March 19, 2024

**ADDENDUM #2**  
**TO THE**  
**BID CONTRACT DOCUMENTS AND SPECIFICATIONS**  
**FOR IFB-2024-16**  
**INTERIOR REMODEL AND SITE IMPROVEMENTS OF ROSELAND ESTATES AND**  
**ROSELAND TOWNHOMES LOCATED IN DALLAS, TEXAS**

**Image #1:** Additions Item #1- Recessed Dryer Venting Box Example

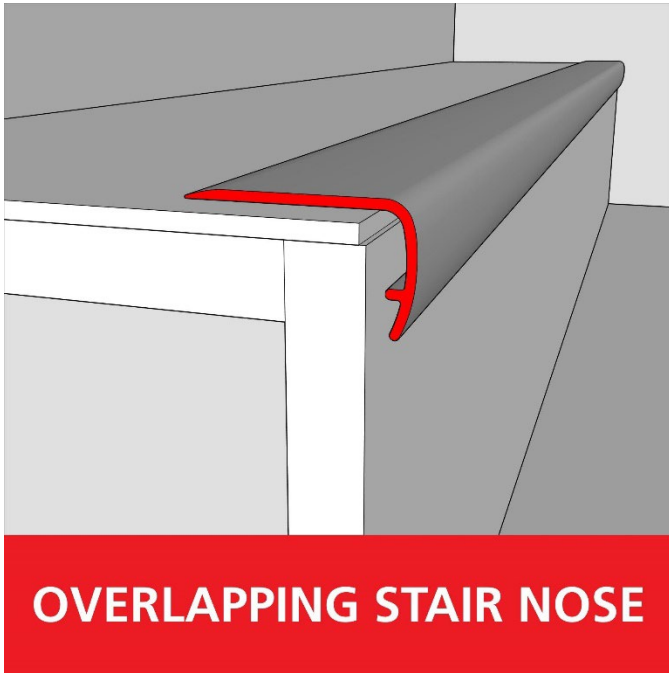
1. Add recessed dryer venting box behind dryer at each location. **See Image #1.**
2. Outlets behind Refrigerator and Washing Machine to be removed and replaced with a simplex outlet.
3. Remove all outdated telephone or accessory outlet plates and repair wall. **See Images #4 & # 5.**
4. **In All Bedroom Closets Only:** Remove any existing Doors, Bifold Doors, or casings. Rough in an opening for a 24” Wide (Two 12” Flat Solid Wood Slab Panels) French Door Style installation. Matching Brushed Stainless hardware. **See Image #2**
5. Contractor shall cover all drain openings after demo/removal of objects to prevent clogging of drain lines.
6. Contractor shall inspect drain lines prior to placing toilets, bathtubs, shower, and sinks to ensure there is no apparent clogging.
